**Ohio Department of Transportation
Office of Traffic Engineering
July 20, 2007**

As of July 20, 2007 four new or revised OTE Plan Insert Sheets (PISs) have been issued.

OTE Plan Insert Sheet Revision Log July 20, 2007 Revision

LATE MERGE

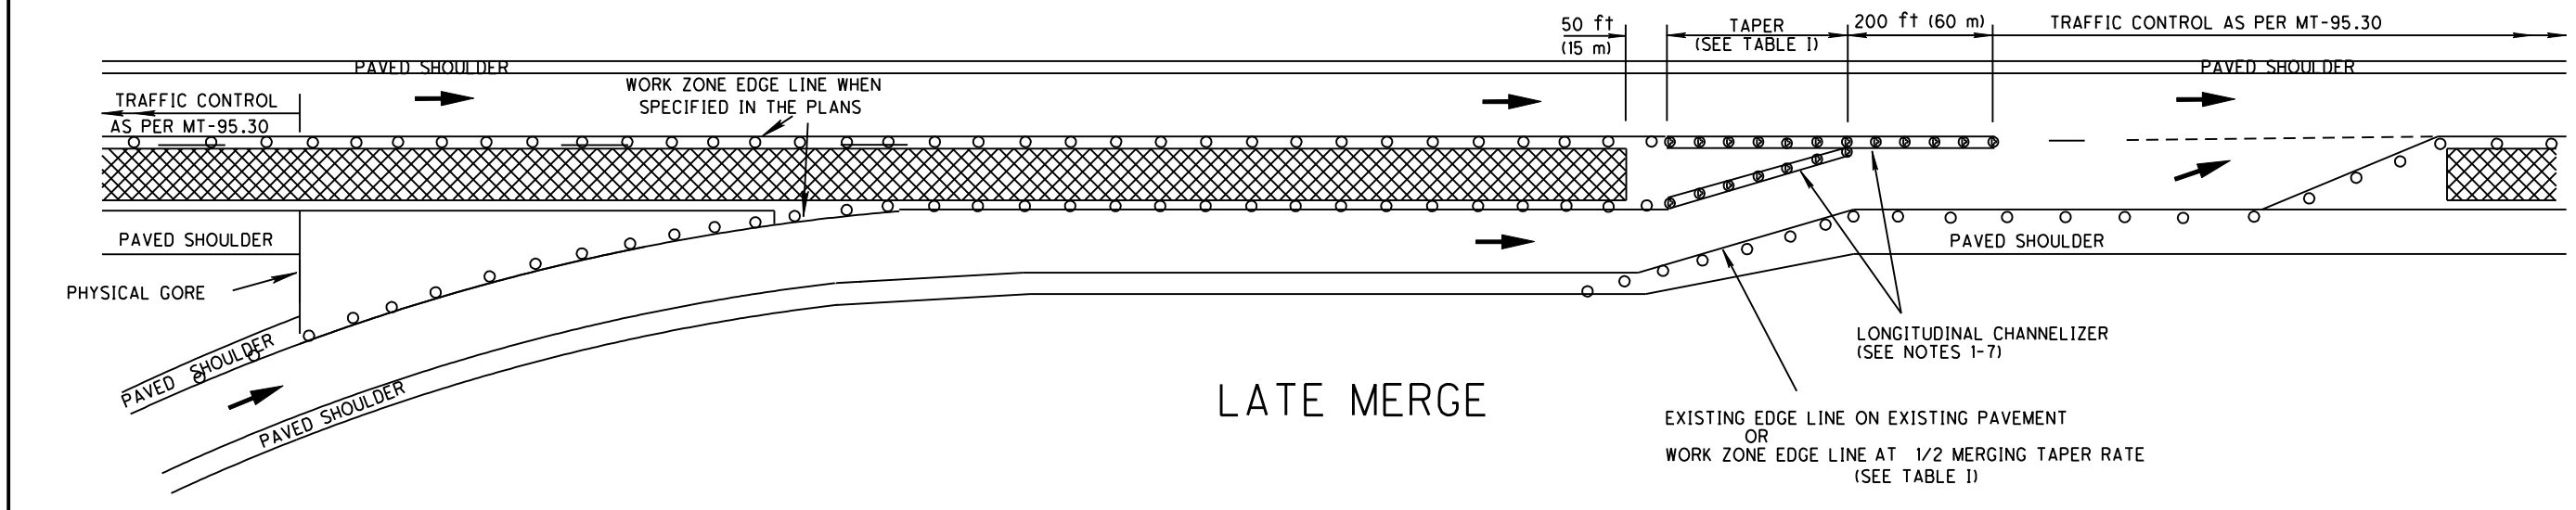
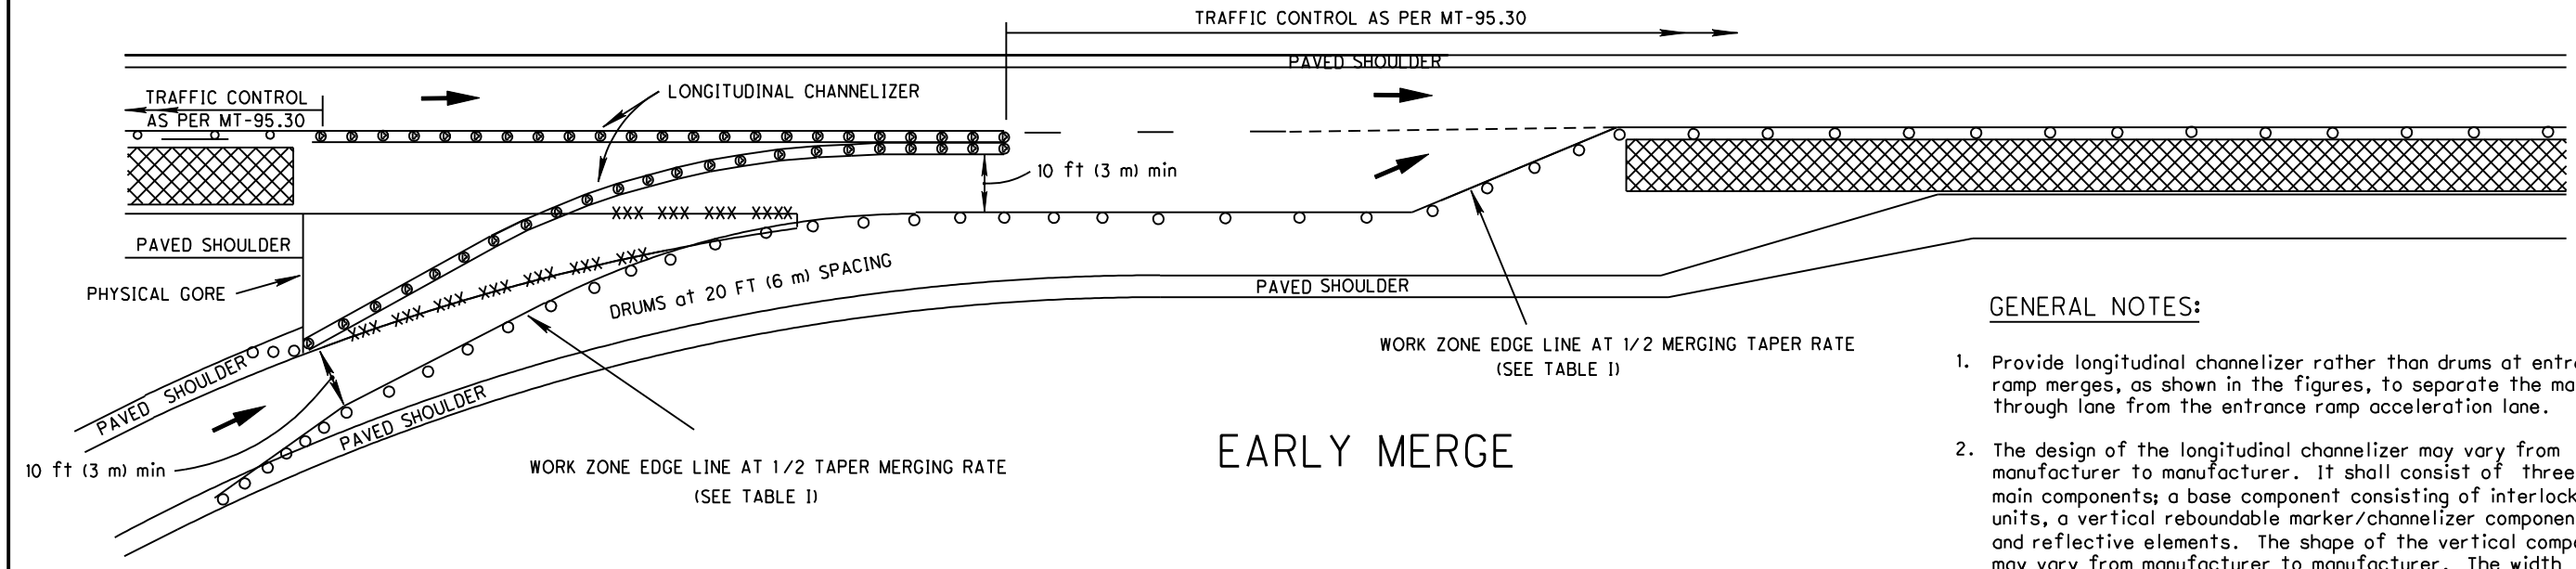
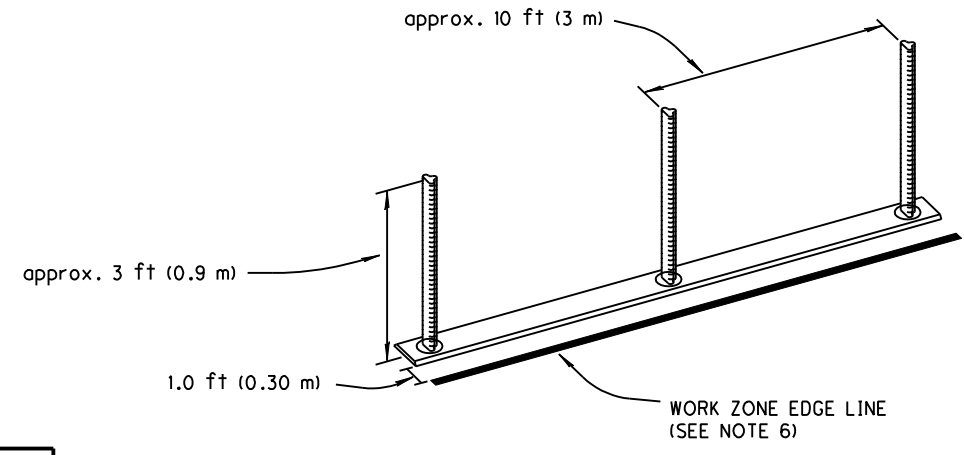
Revision Involves:		Revision Type *	Revision Description
Drawing Number	Title		
<p>*Change - adding new information or revising existing information, more than an editorial change; New - adding a new drawing; Deletion - deleting a drawing; Editorial - revising text to provide clarification, updating references, correcting a typing or drawing mistake, simple editorial changes such as rephrasing a statement or making a format change.</p>			
<p>Plan Insert Sheets [top of page] .</p>			
209930	Work Zone Delineation on Concrete Surfaces	Change	Correction made to Note 3. Changed Qualified Products List to Prequalified List
209931	Work Zone Delineation on Concrete Surfaces	Change	Correction made to Note 3. Changed Qualified Products List to Prequalified List
2010180	Longitudinal Channelizer Detail	Change	Changes were made to the notes describing the Channelizer details. Also made several editorial changes.
